To the Examining Authority.
Written Submission Deadline 8.

Reference: EA1N. IP: 20024031. / AFP 132
EA2. IP: 20024032. / AFP 0134.

These remarks apply both to East Anglia One North and East Anglia Two.

1. Comments on the Outline Code of Construction Practice Rev 4 (REP7-026).

Fig 1.

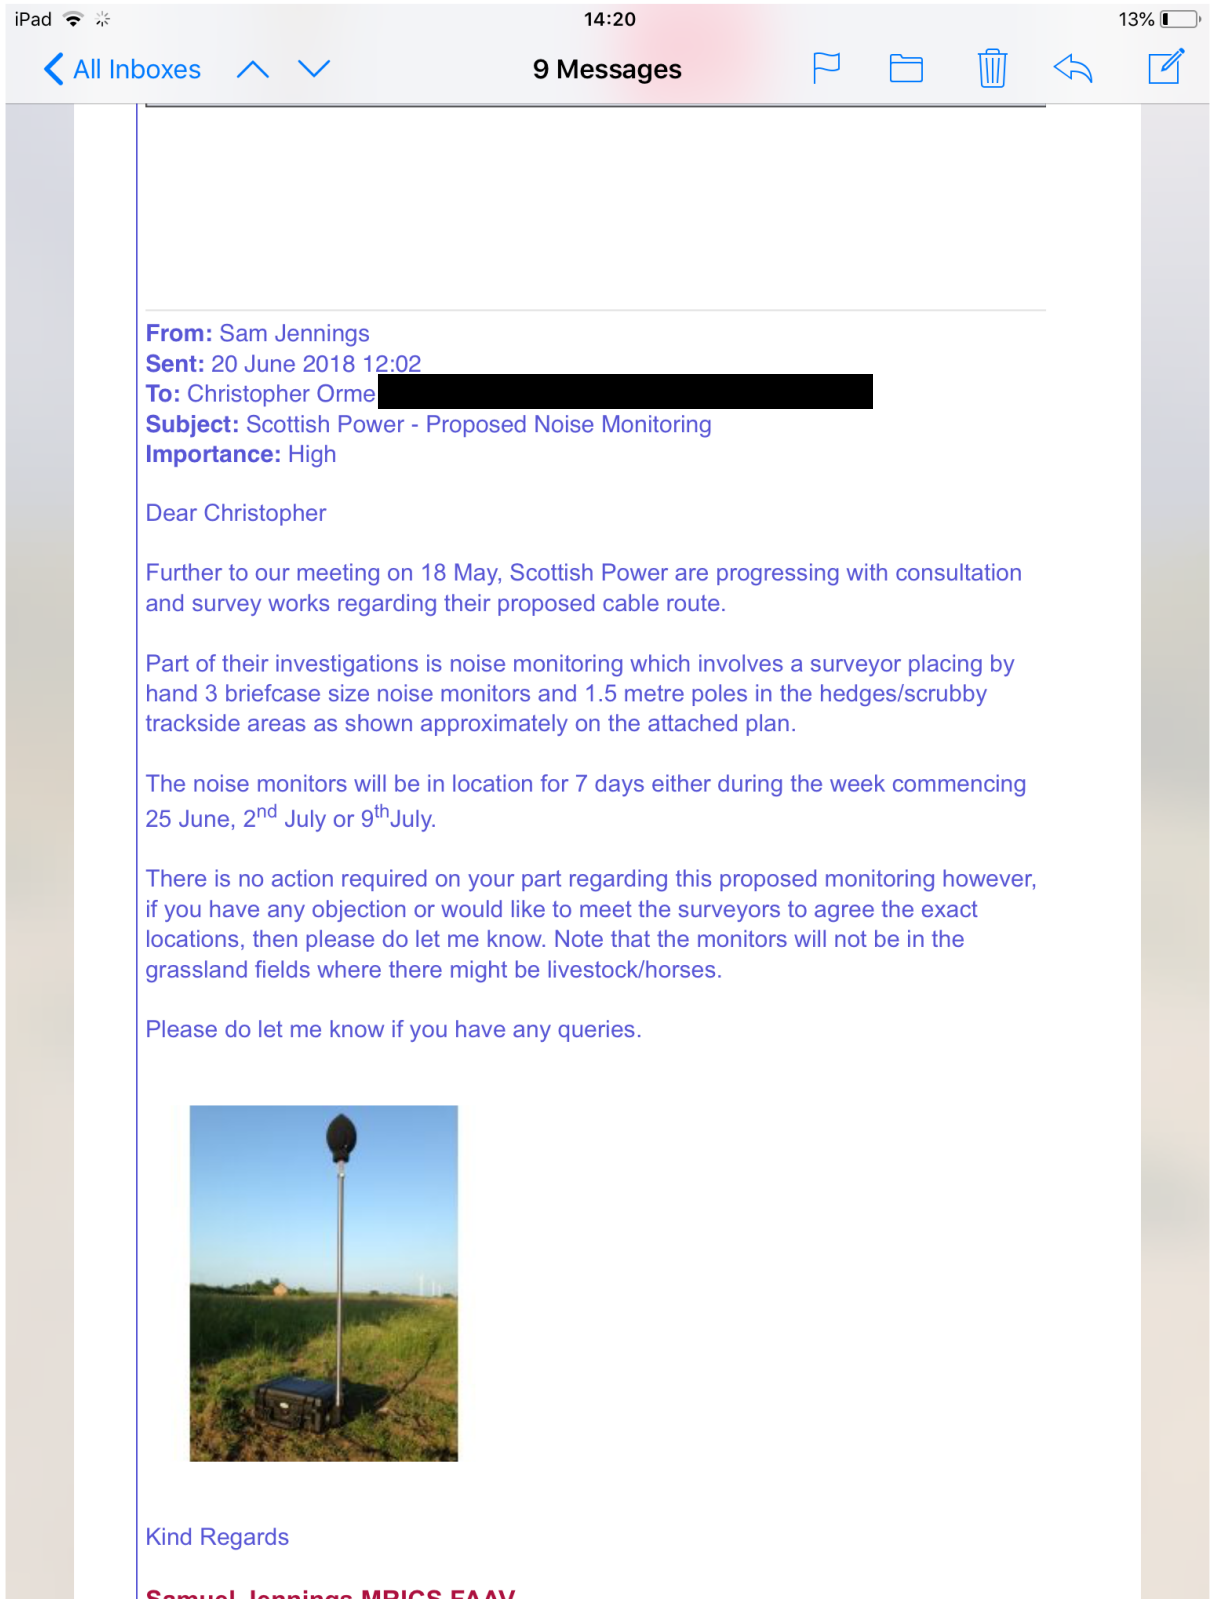
On 20 June 2018 I was notified via my landlord's agent of the Applicant's proposal to place 3 briefcase sized noise monitors and 1.5 metre poles in the hedge/ scrubby trackside areas for noise monitoring at some point for 7 days commencing at some point in the next 3 weeks. Please see attached email screenshot.

An aerial photo was attached showing clearly that the monitors would be sited directly at the bottom of our garden, with a picture of the monitors in question. These are the monitors identified as CCR 1 in Appendix 2, Figure 1. In fact, as the Baseline Noise Monitoring Tables show (APP-524) they are identified with another property at a different location, Courtyard Cottage

In the Applicants Environmental Statement APP-524 6.3.25.3 Table A25.3.4 Baseline Noise Monitoring Locations Onshore Cable Route Study Area, [REDACTED] and [REDACTED] are the only 2 properties cited as the location of noise receptors. [REDACTED] is identified as the address closest to CRR1 on that Table. The period of monitoring is identified as being on 3/ 7/2018 from 13.08.40 to 13.36.40) .

[REDACTED] are significantly further away from the construction site, and one of them is a holiday let and not permanently inhabited. This failure to provide correct information and identify different properties means that our households, at a distance of one modest sized field from the proposed Landfall and encircled by cable corridor works, set down etc, have been excluded from Baseline Noise Monitoring information provided to the ExA, except for a period of half an hour, and there are no studies pertaining to the impact upon them of the works, vehicle and personnel movement. Can the Applicant explain why? “

The point is that the Applicants documentation is claiming that they did make such a survey at this property.
